Remarks and Arguments in Favor of Patentability

Amendments to the Drawings:

Fig. 4B

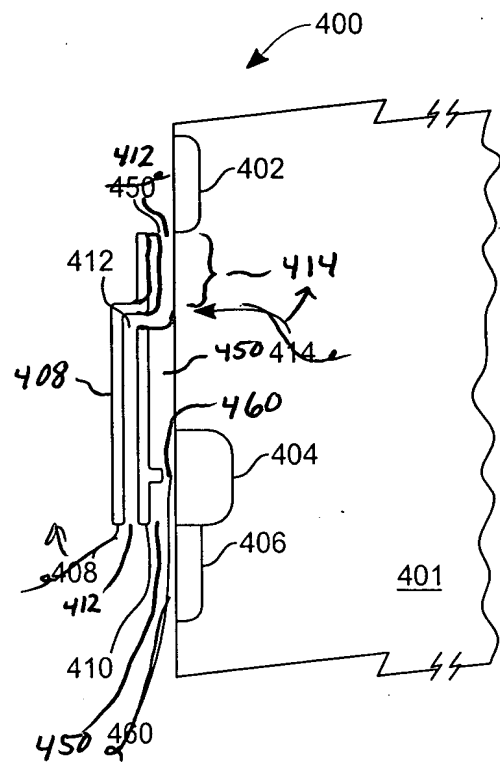
element is supported and clearly distinguishable in amended Fig. 4B, by the elements gate ONO layer 450 and tunnel oxide 460 layer.

Applicant is amending Fig. 4B by adding and/or relocating labels for clarification and closer correspondence to Fig. 5G. Additions and changes are shown in red on the attached copy of Fig. 4B. Each label noted in red is either a relocation and/or copy of a previously used label or is used in paragraphs explaining these figures in the specification.

The label for gate ONO layer 450 is moved to better correlate with corresponding initial gate oxide layer 517 of Fig. 5E. The active region 414 is shown with a brace to better delineate its range. The interpoly layer 412 is now labeled at each extent between source implant region 406 and drain implant region 402. A line of delineation has been added between the gate ONO layer 450 and the inter poly layer 412 at the end of the floating gate 410, closest to the drain implant region 402, which extends down to the substrate surface. This matches with the previous representation of the corresponding interpoly dielectric layer 521 in Fig. 5G. Applicant avers that no new matter has been added as a result of the aforementioned changes.
